Appendix 1: Amendment C81hors Submissions Response Table

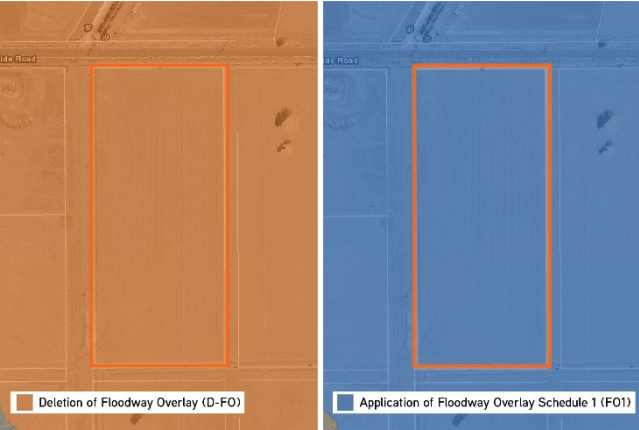
Submitter questions the basis for the application of the LSI01 and FO1 on the northern lot. The submitter highlights that the changes appear to represent the depth of wastewater storages. The submitter seeks reason and necessity for overlays and removal of the overlays from the land shown on the Amendment maps.

Council met with the submitter on 22 March 2023. Technical consultant, Water Technology, conducted a review of the modelling. It was agreed that the FO1 should be removed from the area of land where the wastewater storage plant is located. The overlays are not intended to control alterations to water supply infrastructure operated by [REDACTED] and should be removed from this area. Below is a revised map which illustrates the extent of LSI01 and FO1 to be removed:

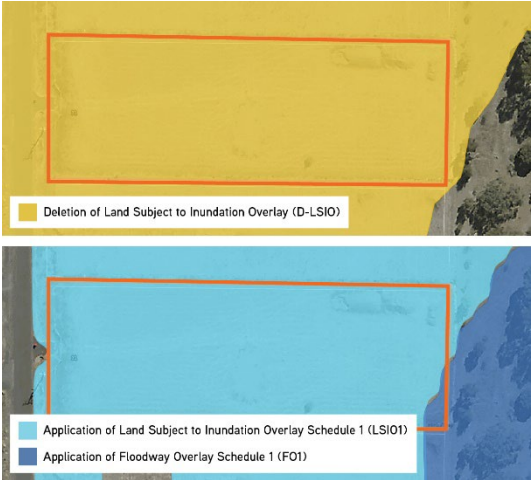
Submitter raises the concern that the proposed LSIO1 and FO1 identified on the Amendment map apply to a dam. This dam is obsolete and it is the submitter's intention to have it filled. The submitter requests that the proposed LSIO1 and FO1 are removed from the previously decommissioned channel area.

Following a discussion between the submitter and Council on 25 March 2023, technical consultant, Water Technology, has conducted a review of the modelling. It was agreed that the FO1 and LSIO1 could be removed from the area of land where the disused dam is located. It was determined by Water Technology that the sandy nature of the soil and course model topography has resulted in an overestimation of inundation extent. Given the likelihood of development in the area the extent can be removed. Below is a revised map which illustrates the extent of LSIO1 to be removed:

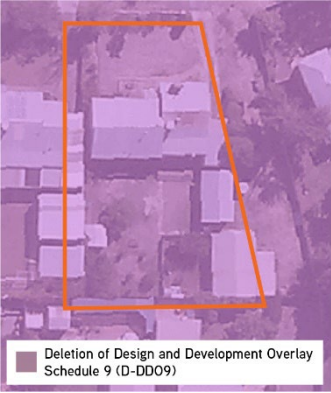
Submitter raises concerns that the existing house pad has not been reflected in the preparation of the Amendment. There is an approved Planning Permit in place for a dwelling and shed and the submitter is concerned that a further extension may not be granted. Insurance was also raised as a matter of concern.

In regards to the existing house pad, during the site inspection held on 13 April 2023, Water Technology reviewed the modelling using survey data from [REDACTED]. Water Technology has advised that the FO1 and LSIO1 should be removed from the house pad. Fill has been placed on the site (as approved by Wimmera CMA and assessed by Water Technology) since completion of the modelling. Below is a revised map, which illustrates the extent of FO1 and LSIO1 to be removed:

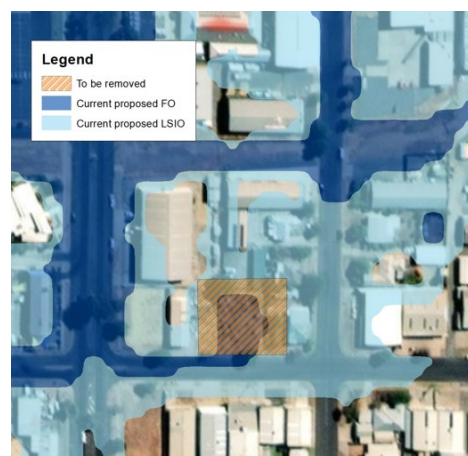
Submitter opposes the Amendment as they are intending to build a factory/warehouse on the land and would like to understand how these changes will impact upon these plans. The submitter also raises drainage and excess stormwater concerns.

During a site inspection held on 13 April 2023, Water Technology and the Wimmera CMA advised that cut and fill may be possible between 3 and 5 Sloss Street to achieve flood depths lower than 0.5 metres. This can assist with supporting development and preventing any impacts to adjoining properties. Water Technology also reviewed the modelling and has agreed to remove the proposed FO1 extent from 5 Sloss Street. The FO1 is generally used to control development in areas of conveyance, rather than water pooling. The depth of water in this area is marginally over the 0.5m threshold for the FO1. Given the context of the site, the FO1 would be overly restrictive and the LSI01 would provide sufficient development control. Below is a revised map, which illustrates the extent of FO1 to be amended to LSI01:

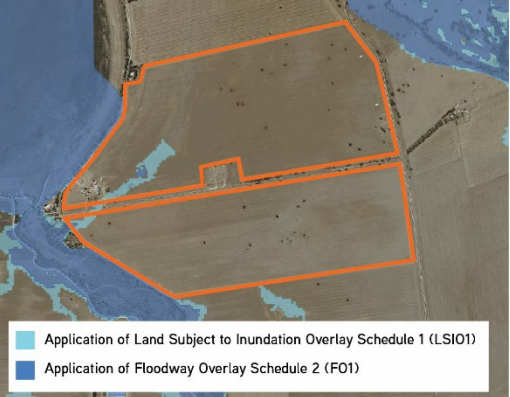
Submitter states that the area for proposed LSIO1 is recorded incorrectly.

Modelling is consistent with historic flood levels across Natimuk. The proposed flood controls are based on the best available information, best practice modelling and techniques, developed over many years by experts in this field. The use of computer modelling is acknowledged as the only practical method to reliably map the extent of changes to the flood shape across the municipality.

At the site inspection, Water Technology conducted a review of the modelling. It was agreed that the section of LSIO1 and FO1 would be removed from the 378 Lake Road, Natimuk. This site inspection also clarified the sandy nature of the soil in the area and it was determined the modelling overstated the inundation. Given the limited likelihood of development the LSIO1 layer can be removed. No change is to occur at 767 Three Chain Road, Natimuk. Below is a map highlighting the proposed mapping changes:

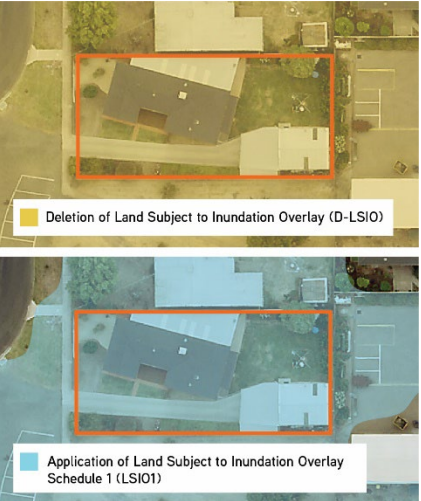
At a one-on-one submitter meeting on 22 March 2023 the accuracy of the LSIO1 extent was discussed for the property. A site visit to the property was agreed to in order to potentially resolve the question as to the LSIO1 mapping accuracy.

The site visit took place on 13 April with Council, Wimmera CMA and Water Technology and it was agreed that the modelling would be reviewed pending a floor level survey to be completed for City Gardens Estate (Market Lane and Rushbrook Close).

The survey was undertaken by [REDACTED] 5 May 2023 and new data was produced as an output of the survey. Water Technology reviewed the 1% AEP water levels that indicates a maximum floor level of 126.7 m AHD in the rear of 2 Market Lane, this compares to a 1% AEP water level of 126.63 m AHD.

Given the floor level of the building was demonstrated to be above the 1% AEP flood level (used to delineate the LSI01 and FO extents), it has been agreed the section of LSI01 would be removed from the dwelling floor area. The modelling showed inundation due to the base LiDAR data misrepresenting the buildings, and interpolating from the road at the front to the pond at the rear as part of the data processing. Below is a map of the proposed revised LSI01 mapping extent for City Gardens:
